**LAND ADJACENT TO JACK STRAW'S CASTLE, NORTH END WAY, HAMPSTEAD, LONDON, NW3 7ES  
PLANNING APPLICATION REFERENCE - 2017/2064/P**

We write in response to your email dated 14 July 2017 that outlined the comments received from LB Camden consultees and other matters raised by yourself, in considering the planning application at land adjacent to Jack Straw's Castle (ref. 2017/2064/P).

**Figure 1 – Jack Straw’s Castle North Elevation**

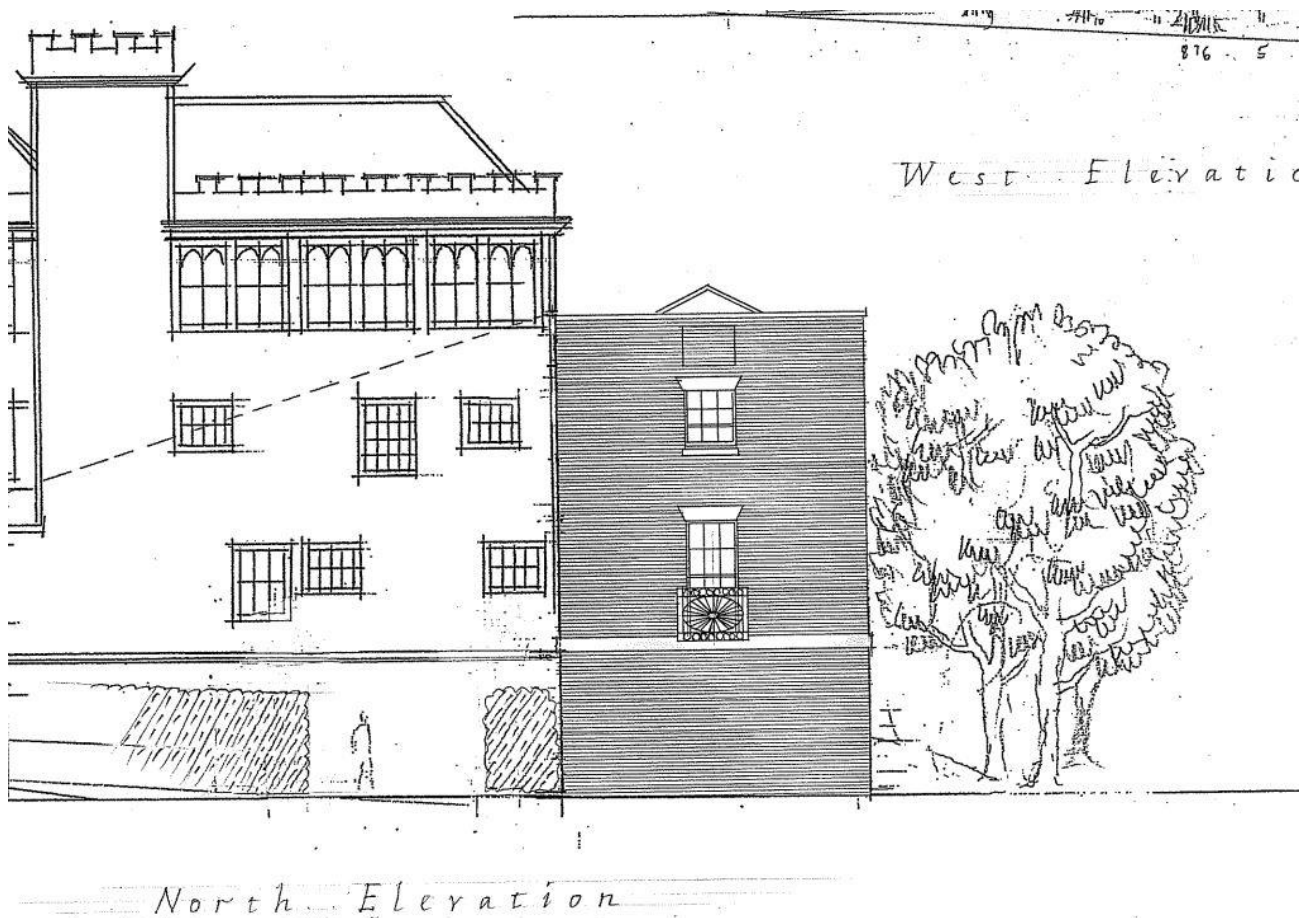
- *“Applicant should confirm that overshadowing assessment has been undertaken and modelling of performance adjusted accordingly, taking into account the orientation of the panels.*
- *The proposals do not include a green roof – all new developments should include a green roof where feasible. This provides ecological benefits and run-off reduction benefits.”*

XCO2 also noted that the proposed PV panels are on the west facing pitched roof and as such would not be overshadowed by the building to the South as can be seen within the north elevation reproduced in **Figure 1** below.

**Figure 3 – Relationship of site with adjacent Metropolitan Open Land Designation**

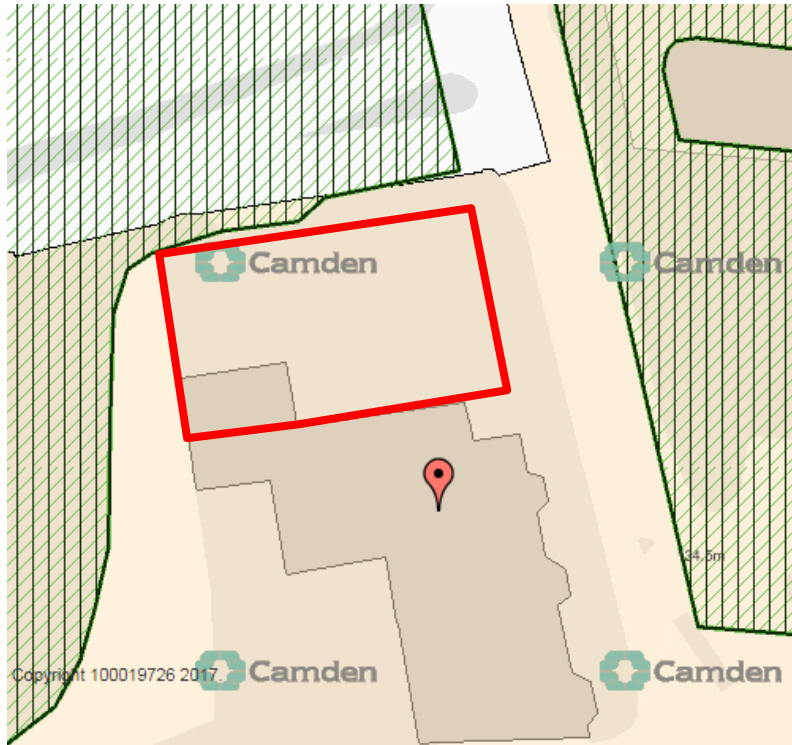
In addition to Camden's responses, we note that the City of London commissioned an external planning consultant to prepare representations to the application. The representations state that the site may be partially within Metropolitan Open Land. We find this report particularly disappointing, and, being candid, misleading, as it incorrectly extends our client's site boundary into the MOL.

The application site is not located within MOL.

We have overlaid the correct site boundary above the Camden Planning Policy Map, which is shown in **Figure 3**. This is further south than shown in the City of London representations. We note that Camden's base map is incorrect insofar that it continues to show the former garages attached to Jack Straw's Castle, which were formerly located within the site boundary.
